PIAC's Submission on Ausgrid's 2019-24 Capex Proposal

17 August 2018

Figure 1 – Ausgrid actual and estimated non-network capex, 2014/15 to 2019/24 (\$m, real FY2019)

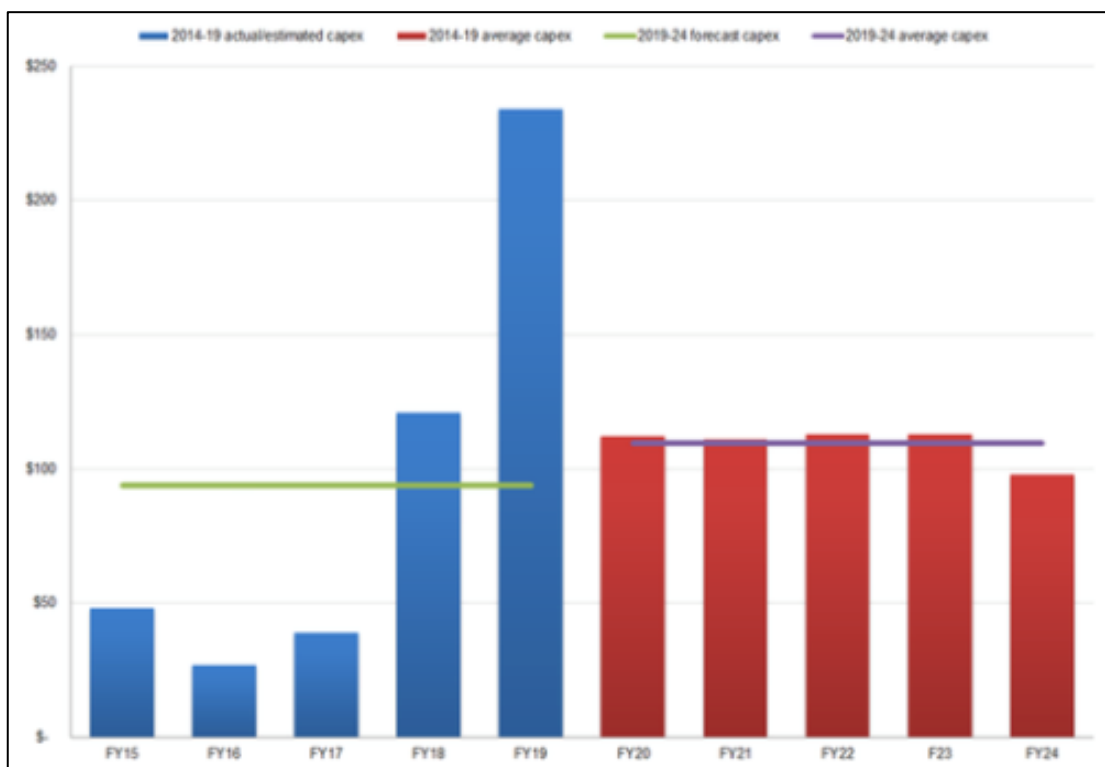
Ausgrid's proposed non-network capex is a real increase compared to 2014-19 period, despite the very significant increases that Ausgrid estimates for the last two years of the current regulatory period. This is illustrated in Figure 1.

PIAC considers that there is scope for reductions in Ausgrid's non-network capex proposal. For example, Ausgrid's proposal for a further \$209m for 'Property' and \$124m for 'Fleet and Plant' seems to be excessive in the context of:

- The very significant capex in the 2009-14 period; and
- The significant downsizing in staff and outsourcing of much of the capital program in the current regulatory period 2014-2019.

AER should review property and fleet/plant expenditures in the context of Ausgrid's reduced staffing levels and increased outsourcing.
